Comment Date: May 2, 2011 14:17:41PM
Solar Energy Development PEIS
Comment ID: SolarD11812

Re: Endorsement of Cultural Resources Preservation Coalition Letter on Solar PEIS

Re: A NEPA EIS is no substitute for required FLPMA regulations

Figure 2. Suggested zone for studying the possibility of SEZs in the West Mojave.

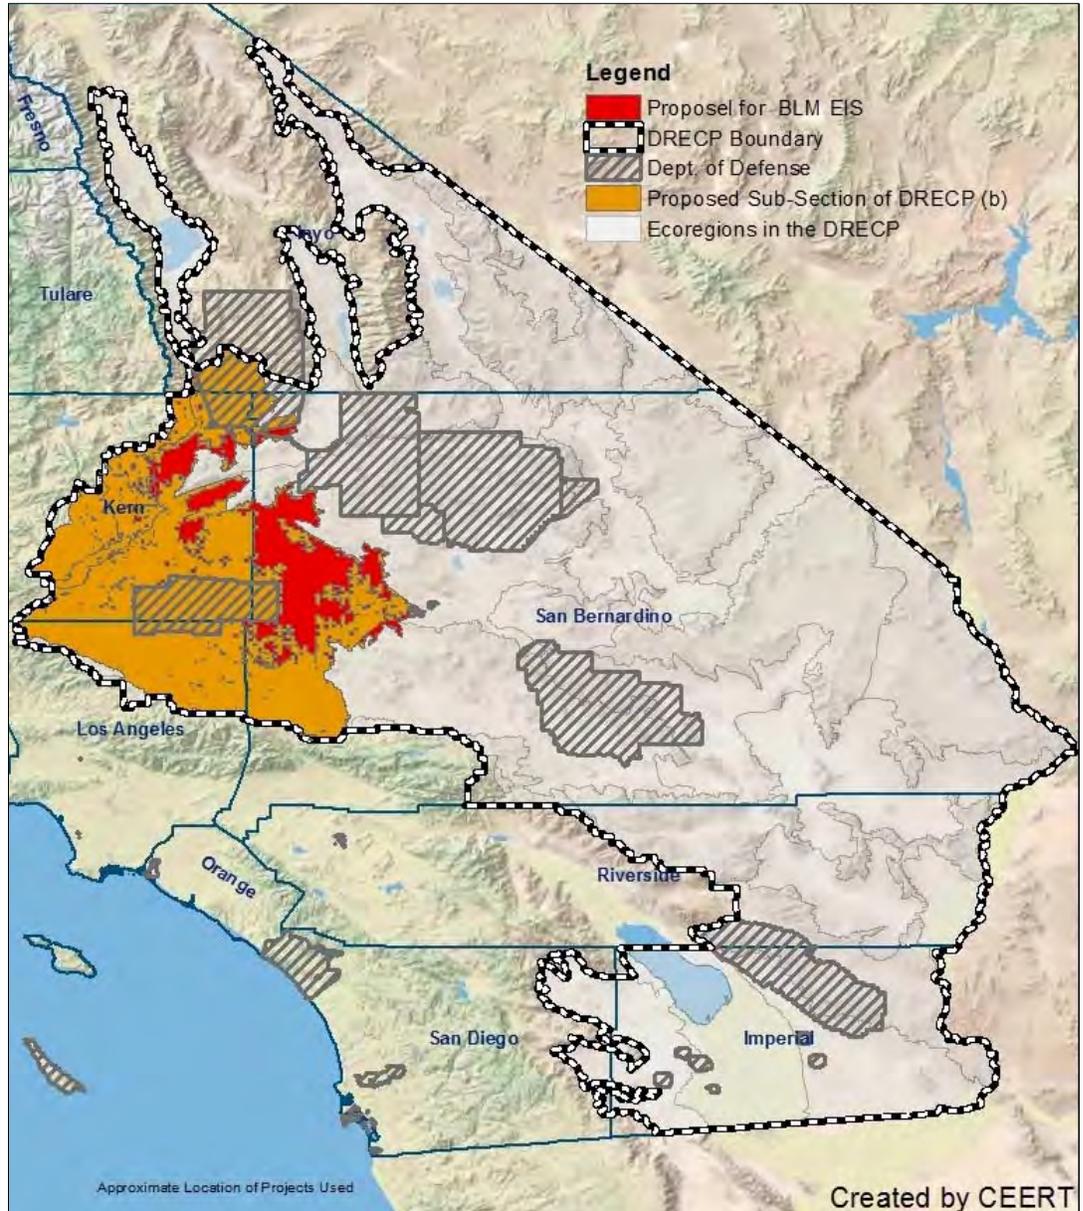
Admittedly, BLM’s planning and review of the West Mojave will require significant resources. Efforts being undertaken in other contexts may be leveraged to save some time. For example, the State of California, through the California Energy Commission, has recently launched an extensive vegetation mapping exercise, the results of which should provide important and timely information for the BLM’s review of the WEMO Plan, and for the California DRECP. In addition, CEERT, as part of its coordination of California’s Renewable Energy Transmission Initiative (RETI) planning effort, has developed a map of the West Mojave which identifies the recommended areas which should be evaluated by BLM as part of its analysis of the West Mojave as a new SEZ. Even with these resources, there is still much work to be done to identify SEZs, but it will

be worthwhile to provide for development opportunities in this region with unparalleled solar resources.

Figure 3. Proposed starting point for SEZ evaluations in the West Mojave.

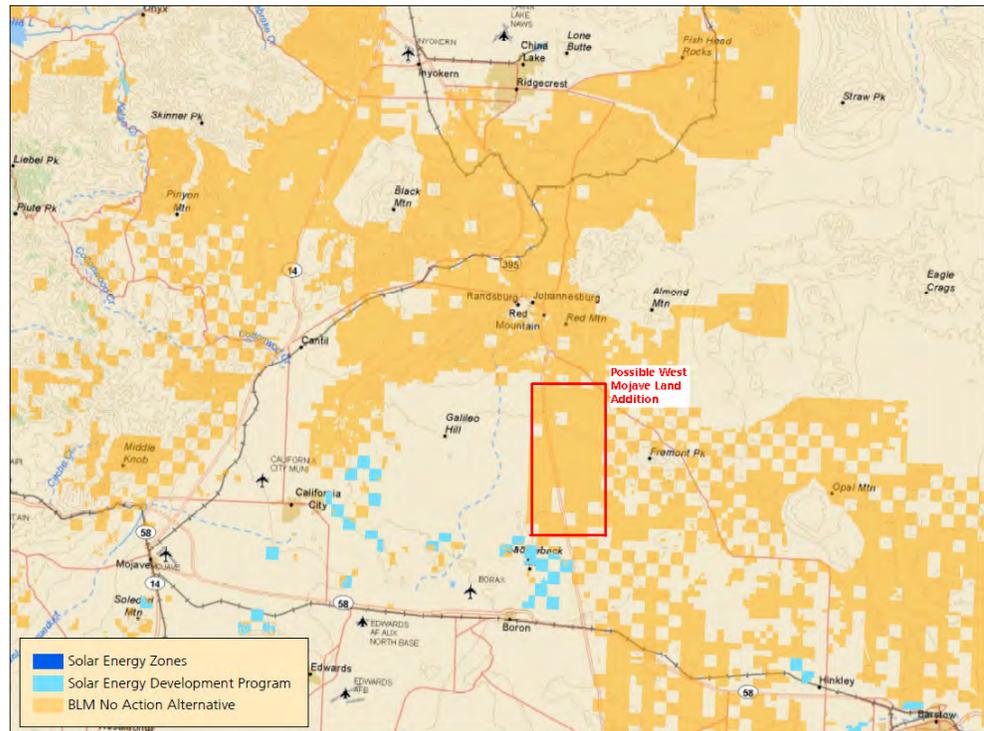
Solution: As stated above, BLM should establish a consistent process for identifying and approving new SEZs or SEZ expansions (assuming, of course, that those SEZs follow the recommendations we have laid out above). Such process will be important if BLM designates SEZs, and BLM should identify that process in the Final PEIS. BLM also should begin evaluating new potential SEZs in the West Mojave, Chocolate Mountains, lands identified in the Arizona Restoration Design Energy Project, and other areas. Figure 3 below depicts one possible area for West Mojave utility-scale solar development.

Pisgah

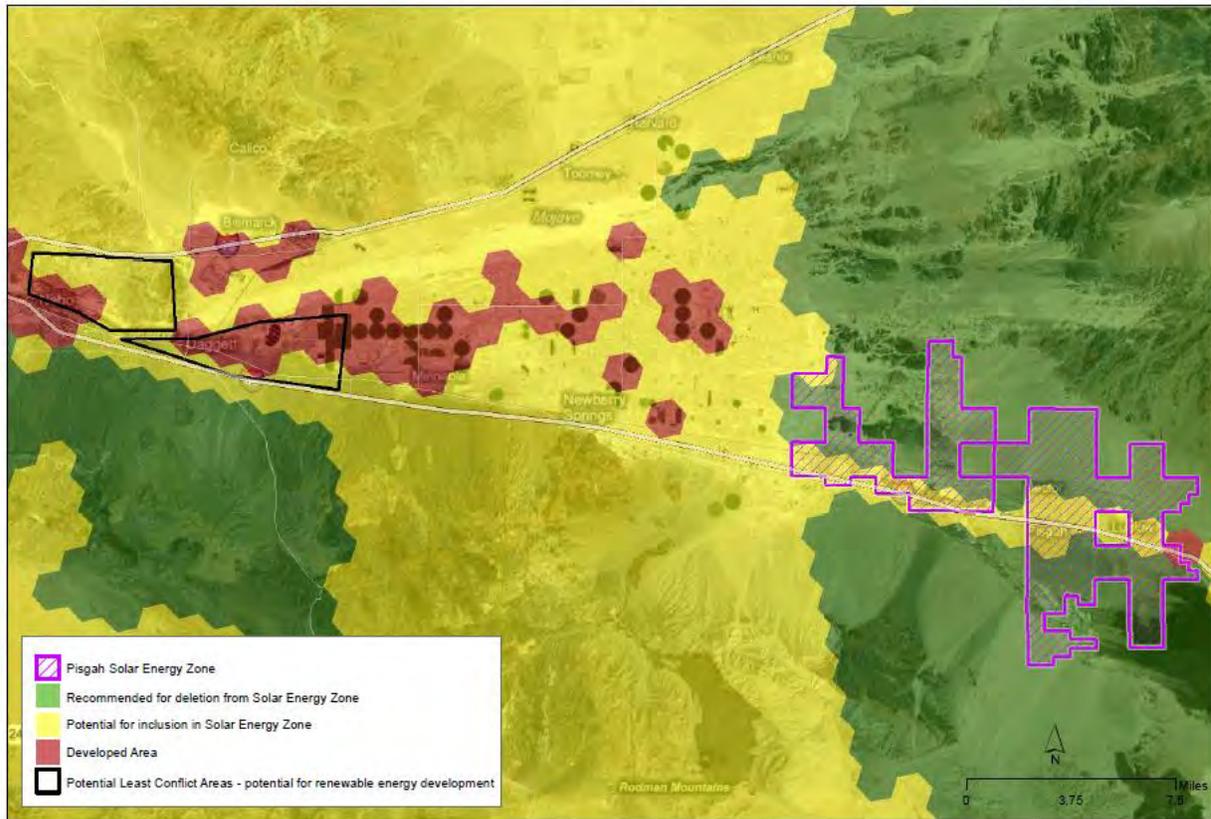
Nearly 80% of the Pisgah SEZ is comprised of ecologically core land; just over 20% of this land has a lower conservation value. Pisgah is immediately west of the triangle formed by the junction of southbound Interstate 15 and westbound Interstate 40 and near private, disturbed lands that already house an out-of-service solar array. The Conservancy recommends the Pisgah SEZ be withdrawn from consideration for ROW applications. Instead, the private lands immediately to the west may serve to replace this SEZ.

Figure 6. Amargosa Valley SEZ

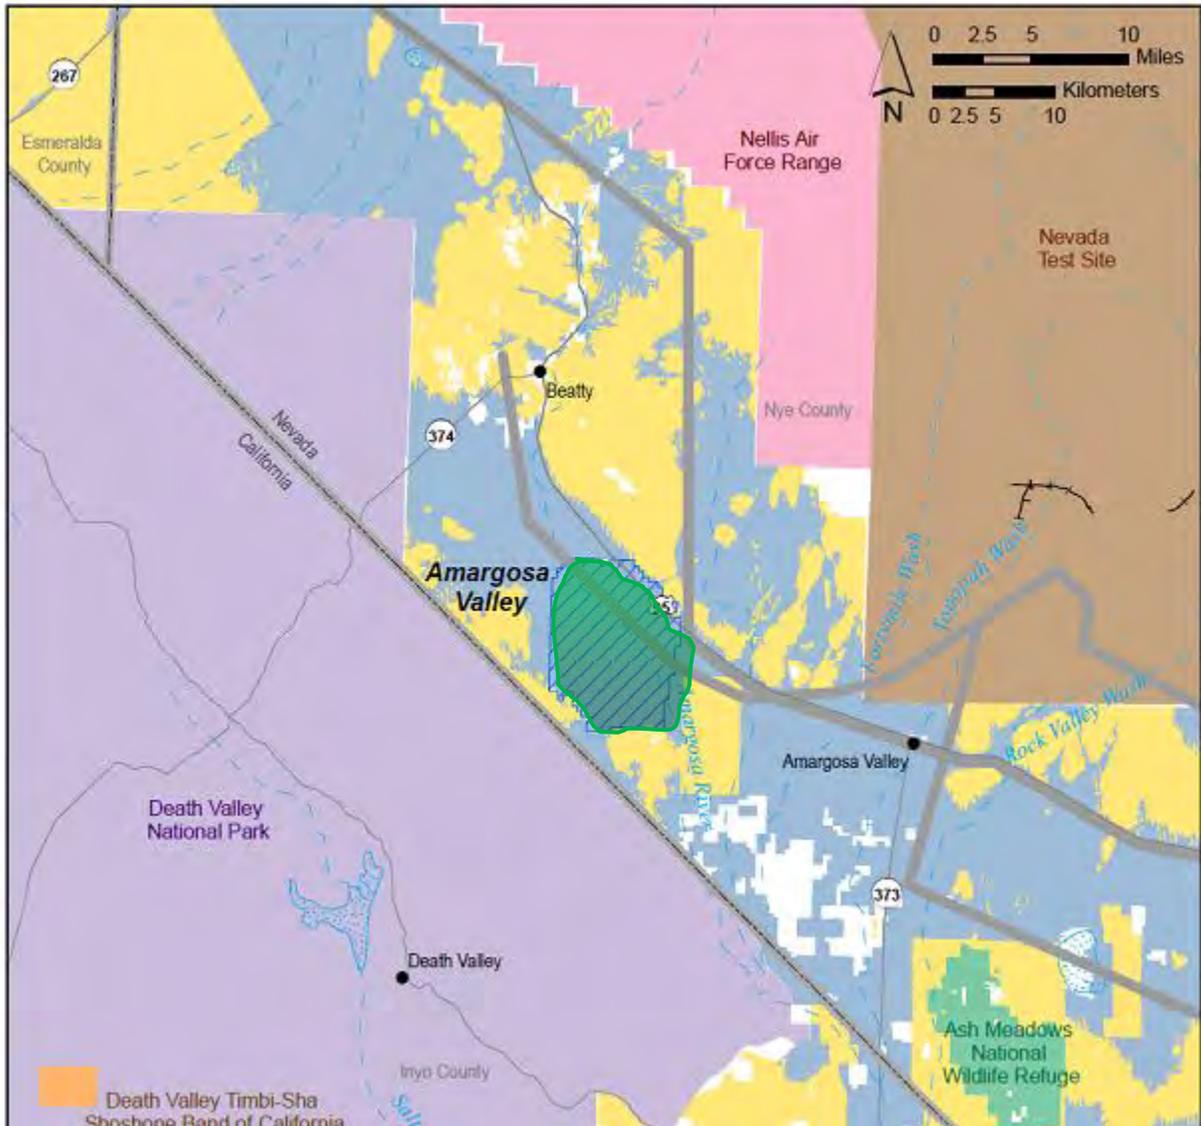
This valley (Figure 6) is already scheduled to be heavily compromised by ongoing existing renewable energy applications, two of which are on the fast track course. There has been no explanation why additional facilities are needed in this general area given the scale of the existing proposed facilities. According to the 2010 TNC Ecoregional Assessment for the Mojave Desert, the overwhelming majority of this SEZ is contained within Ecologically Core zone with an additional 4,500 acres of Ecologically Intact lands. Only roughly 11% of this SEZ is within Moderately Degraded category, and that principally located along US Highway 95.

This valley is located within an important corridor of movement for desert tortoises in light of projected climate change. Currently occurring at low densities, this very lightly impacted valley of Mojave creosote-bursage scrub may be an important population center for this enigmatic desert species if climate trends continue. The Amargosa Valley groundwater basin is already overallocated and linked to critically important desert oases such as Oasis Valley to the north and Ash Meadows to the southeast. Additionally, the presence of Big Dune at the core of this valley should cause concern that the proliferation of renewable energy facilities will interrupt important sand transport pathways from the Amargosa River bed and nearby dry lake beds to the south and east of this valley (Figure 7).

If there is a credible argument to be made for additional renewable energy to be generated in this vicinity after the build-out of several existing fast track and prior applications for solar facilities, then any additional development should occur only in the moderately degraded corridor paralleling US 95. Otherwise, this SEZ should be eliminated from further consideration.

- Ecologically core and intact acreage recommended to be removed from SEZ consideration

Figure 8. Delamar Valley SEZ

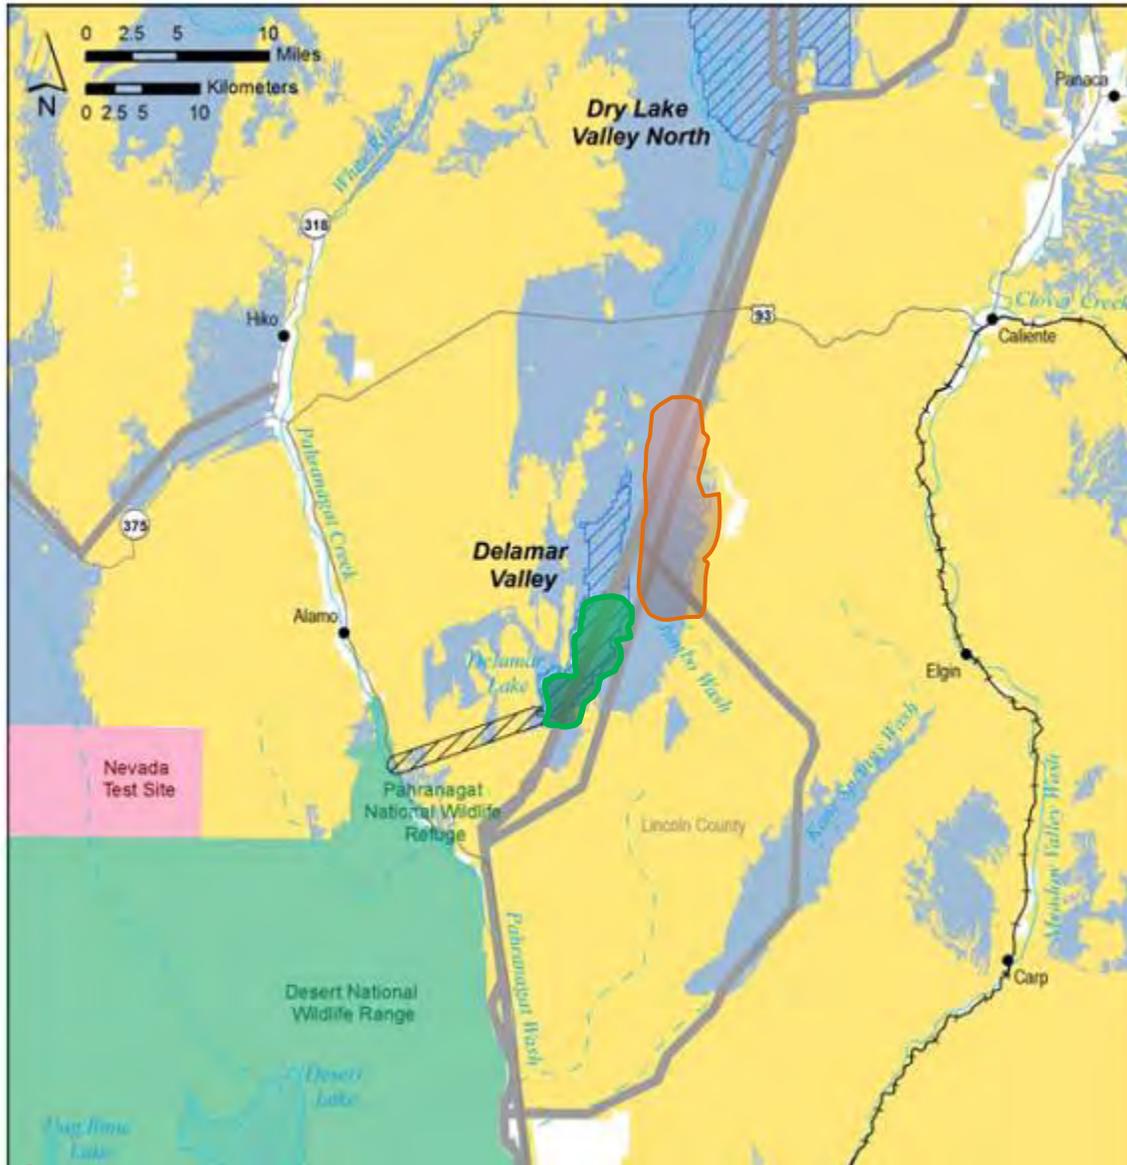
This SEZ is located outside of the Mojave Desert ecoregion, but is proximate to several ecoregionally important conservation sites such as Pahrangat Valley, the Hiko Wash, Warm Springs/Moapa/Muddy River, Ash Springs and Desert National Wildlife Refuge. The underground hydrology is too poorly understood to allow further drawdown of groundwater within a reasonable range from these desert wetland habitats, all of which contain endemic and federally listed species. The location is remote with no proximate significant end user of power generated there. The majority of this SEZ is apparently on intact landscapes, but of primary concern is the presence of Jumbo Wash through the center of it. Any facility approved within this SEZ should be sited north of Jumbo Wash away from the desert playa wetlands at the southern tip of the SEZ.

If renewable energy generation is needed and justified in this general area, the acreage containing the playa wetland at the southern tip of the SEZ should be removed from consideration. That acreage may be replaced to the northeast of the current configuration with little impact on local wildlife, and any technology approved in this SEZ should be as minimally consumptive of water resources as possible.

-  - recommended area to move appropriate facility location
-  - recommended avoidance zone

Figure 10. East Mormon Mountain SEZ

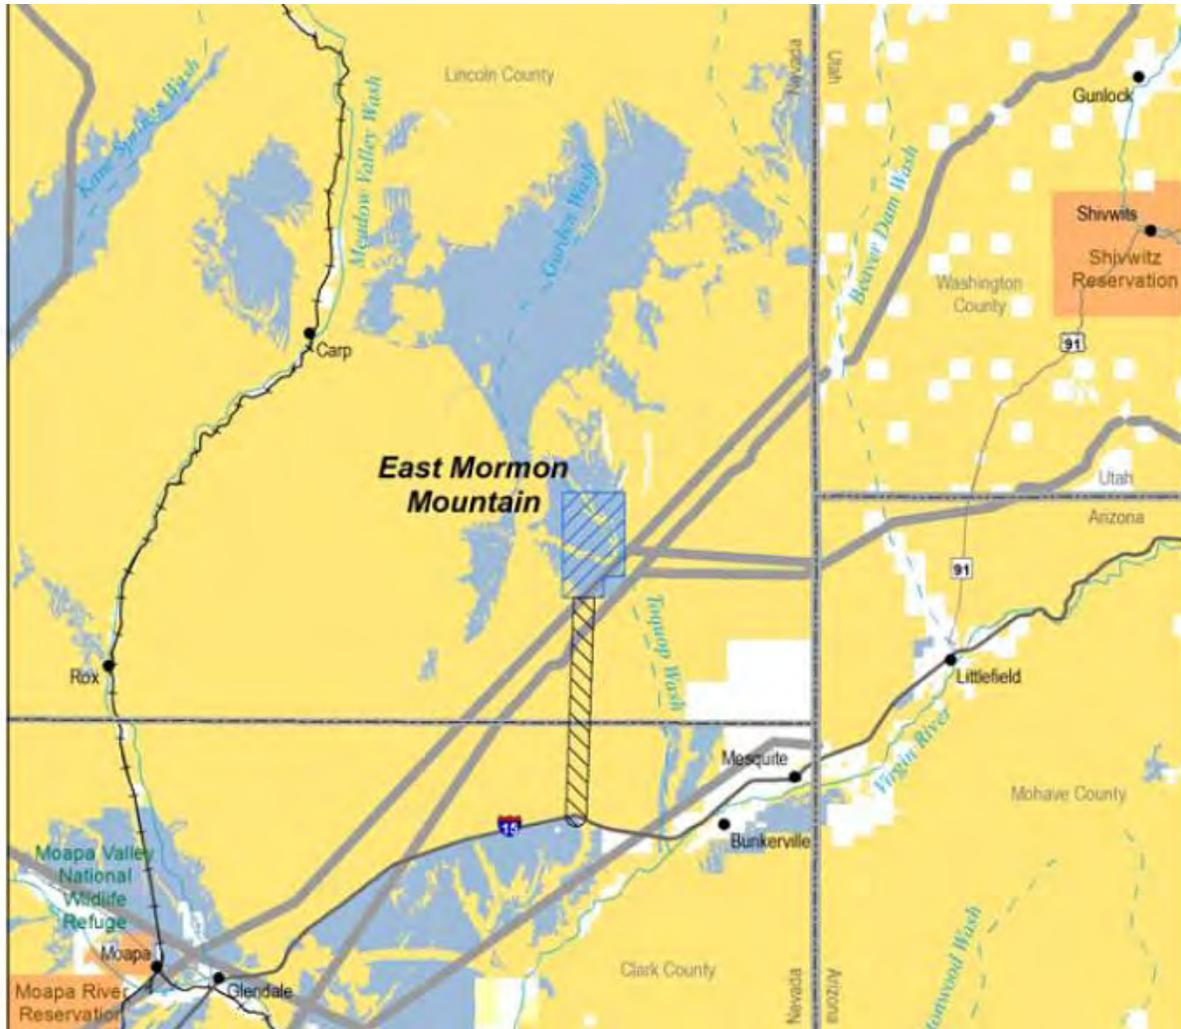
Toquop Wash should be avoided for the siting of any facility developed within this SEZ since it is a regionally important desert wash containing many of the Mojave Desert ecoregionally significant plant and animal species such as gila monster, desert tortoise, sidewinder, American badger, bobcat, southwestern burrowing owl, phainopepla, and catclaw acacia, among many others.

The location of a large renewable energy facility is unlikely to significantly compromise what has already become a major invasive weed breeding ground. Nevertheless, further fragmentation of an already poorly configured Desert Tortoise DWMA (Mormon Mesa), by means of transmission line corridors, should be avoided. The Toquop Wash should be avoided completely.

Figure 11. Gold Point SEZ

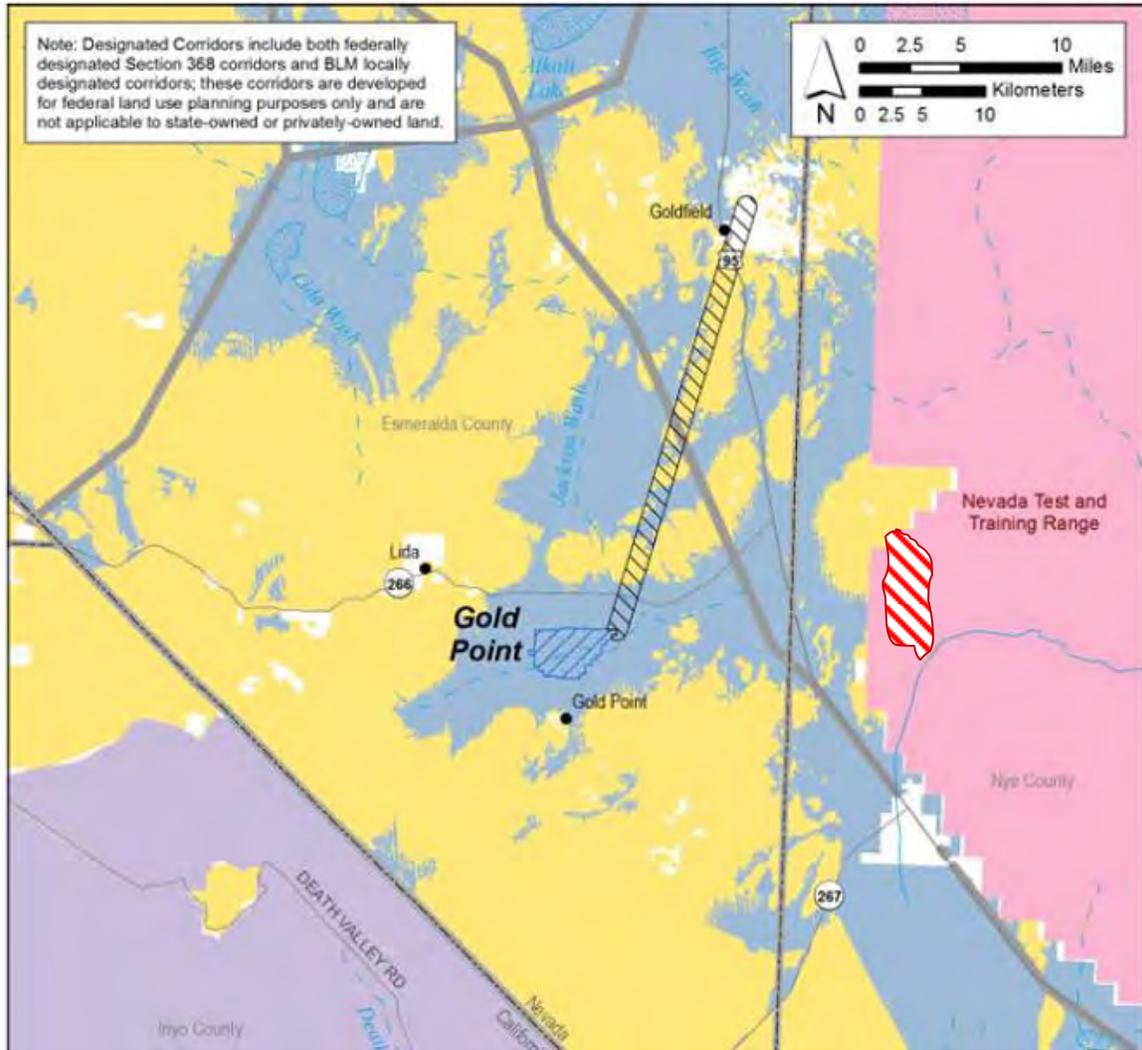
The general vicinity serves as habitat for several locally important species as identified in the PEIS such as Pronghorn antelope and Greater Sage Grouse. The proposed transmission corridor is particularly problematic for both of these species. Moving the SEZ location to the recommended zone would also alleviate these transmission corridor concerns since the new corridor could parallel US 95 without appreciable additional impacts to the species mentioned.

This SEZ is remote and not regionally significant as far as demonstrated power needs and furthermore is currently ecologically intact. It should be removed from consideration or relocated to the only nearby degraded or converted acreage at the intersection of US Highway 95 and State Road 264 as indicated on the map.

- Moderately degraded land to transfer SEZ acreage
